CITY OF ALBUQUERQUE

RE: **Kelly Residence**
9205 Black Farm Lane NW
Request for Pad Certification- Accepted
Grading Plan Stamp Date: 8/1/18
Certification Dated: 11/29/18
Hydrology File: A11D016A

DRAINAGE AND TRANSPORTATION INFORMATION SHEET (REV 6/2018)

<p>ENGINEER'S SEAL</p>	<p>9205 BLACK FARM LANE</p>	<p>DRAWN BY DEM</p>
	<p>GRADING AND DRAINAGE PLAN</p>	<p>DATE 7-30-18</p>
<p>8/1/18</p>	 <p><i>Rio Grande Engineering</i></p> <p>1606 CENTRAL AVENUE SE SUITE 201 ALBUQUERQUE, NM 87106 (505) 872-0599</p>	<p>SHEET # C1</p>
<p>DAVID SOULE P.E. #14522</p>		<p>JOB # _____</p>

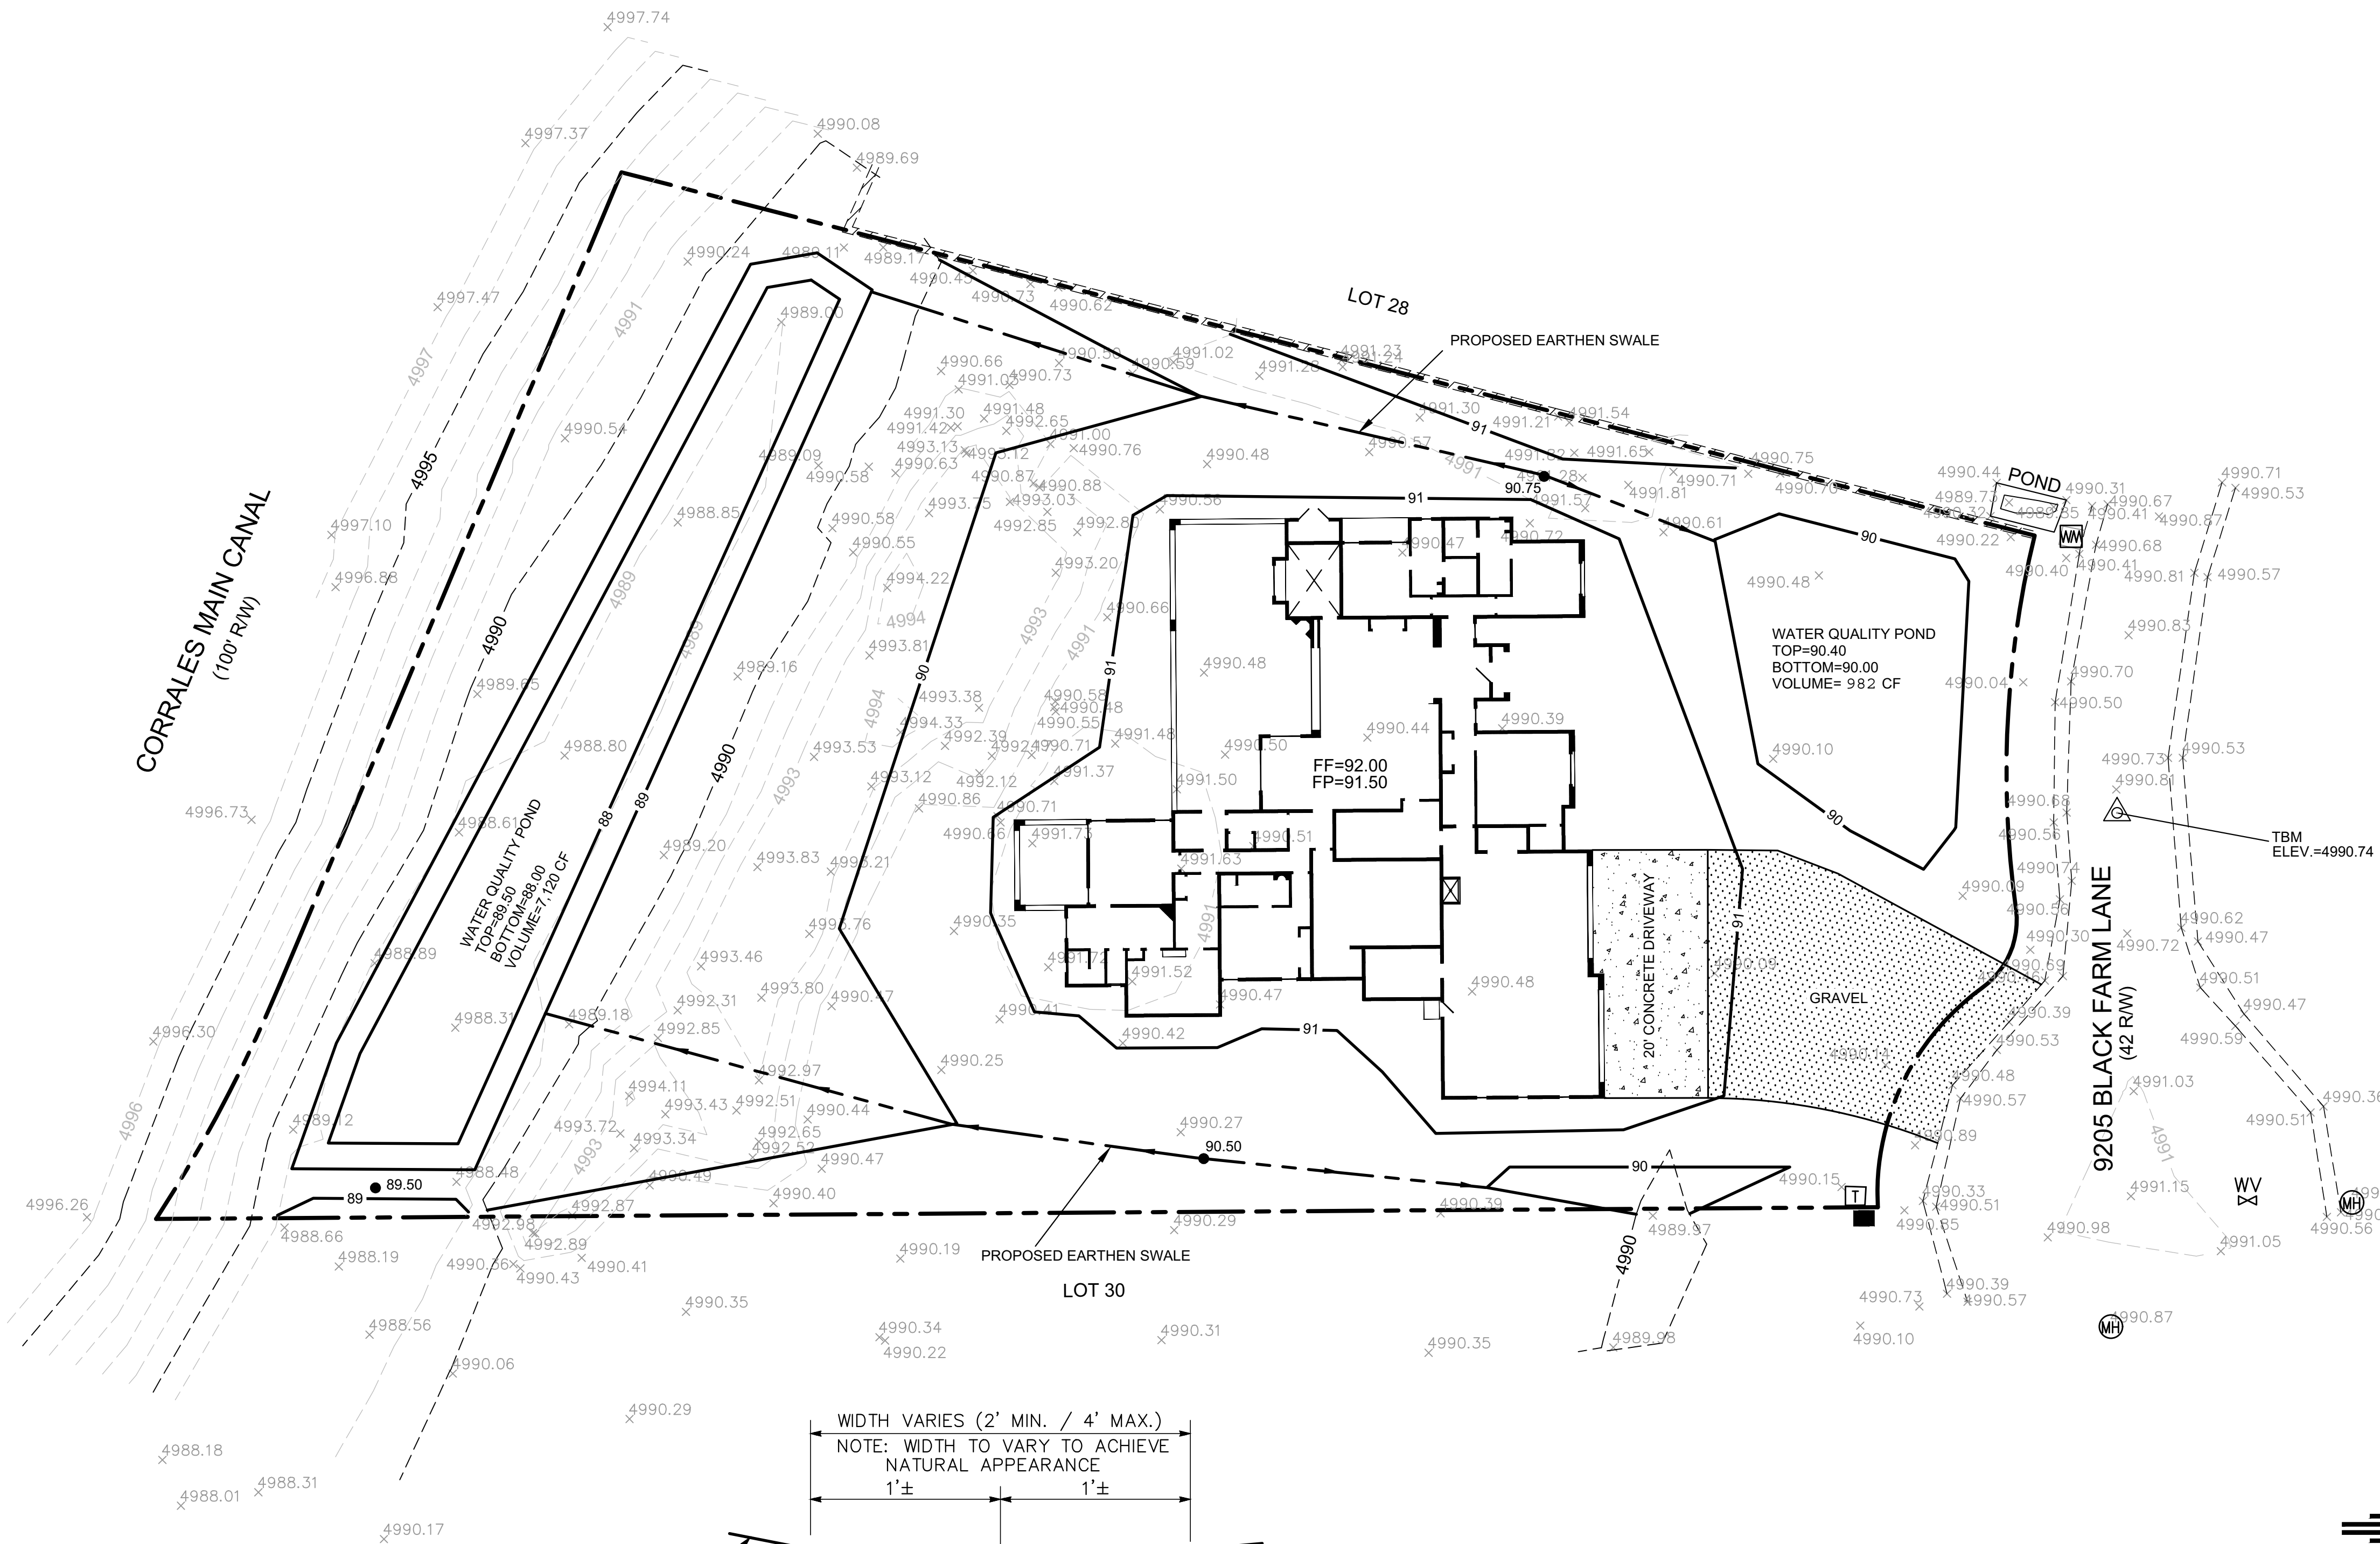
Based on the submittal received on 11/29/18, the Pad Certification is approved for Building Permit.

1. Engineer's Certification, per the DPM Checklist, will be required to ensure the ponds remained intact following home construction.
